### Proposed Revisions to a Standard Plans Index

Index Number: 700-011

Index Title: Single Column Cantilever Ground Mounted Sign

LAST REVISION 11/01/22	DESCRIPTION: 11/01/22	FDOT FY 2022-23 STANDARD PLANS	SINGLE COLUMN CANTILEVER GROUND MOUNTED SIGN	INDEX 700-011	SHEET 1 of 2
---------------------------	--------------------------	--------------------------------------	---	------------------	-----------------

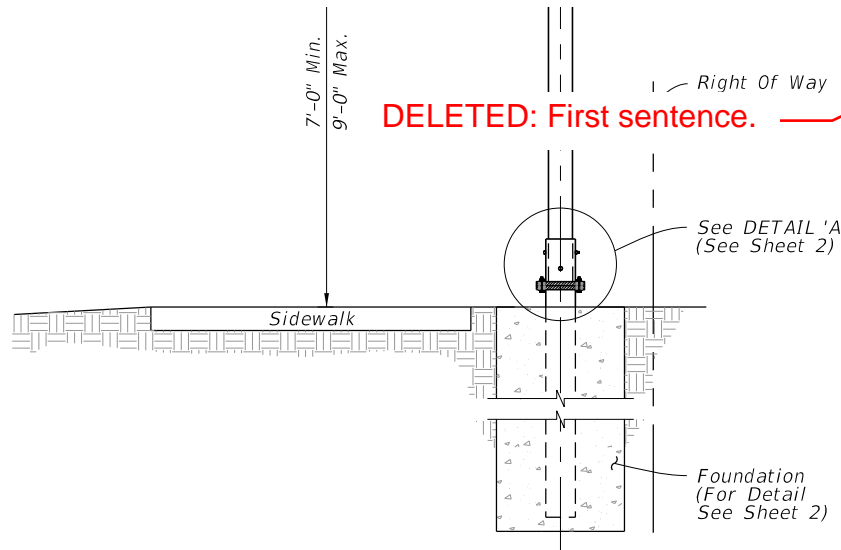
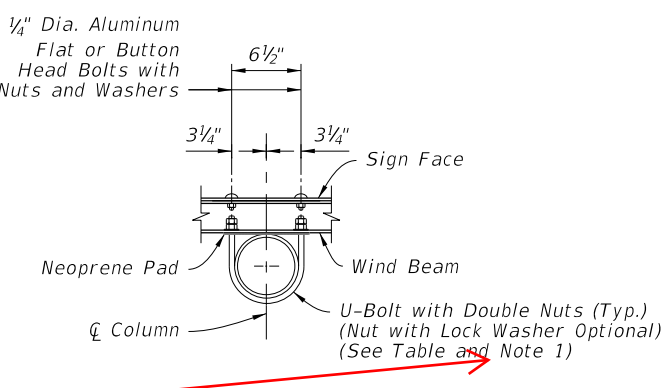
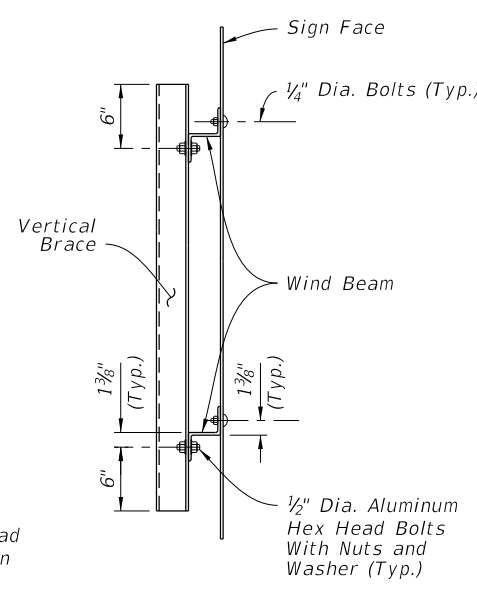
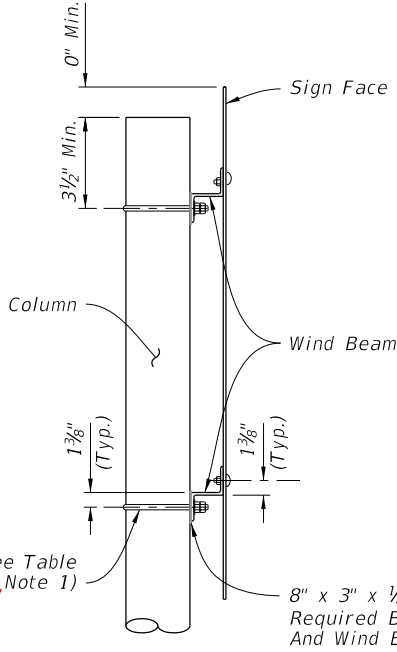
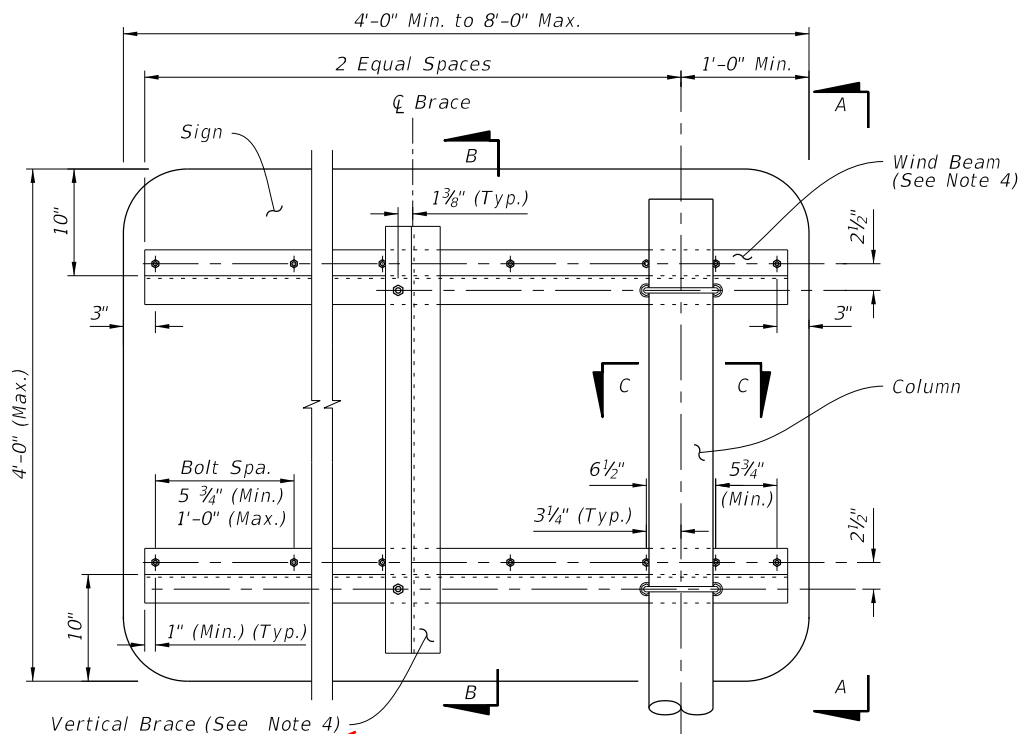
**GENERAL COMMENT:** Material information was deleted. Information is either already covered in Standard Specifications OR will be added to Section 700, 962 or 965 in conjunction with these revisions.

**UPDATED NOTE 1:**  
Work with Index 700-010 for additional notes and the assembly of base connection.

**NEW NOTE 2:**  
Meet the requirements of Specification 700.

- ~~1. Refer to Index 700-010 for additional notes, assembly of base connection and material specifications not given in this Index.~~
- ~~2. Aluminum Columns. ASTM B429 Alloy 6061-T6.~~
- Place galvanized steel shims between the Sleeve and Post to obtain a tight fit between the Post and Sleeve.
- Wind Beam and Vertical Brace: Aluminum Z 3 x 2<sup>1</sup>/<sub>16</sub> x 3.38. Install Vertical Brace on 7'-0" to 8'-0" signs only.
- ~~5. Provide 2 - 0.0149" Thick (28 gauge) and 2 - 0.0329" Thick (21 gauge) Brass Shims Per Post. Used brass shims to plumb the post.~~
- Use nylon washers under the button bolt heads to protect sign sheeting. Use aluminum washers under nut.

**DELETED:** First sentence.

**UPDATED:** See General Note...
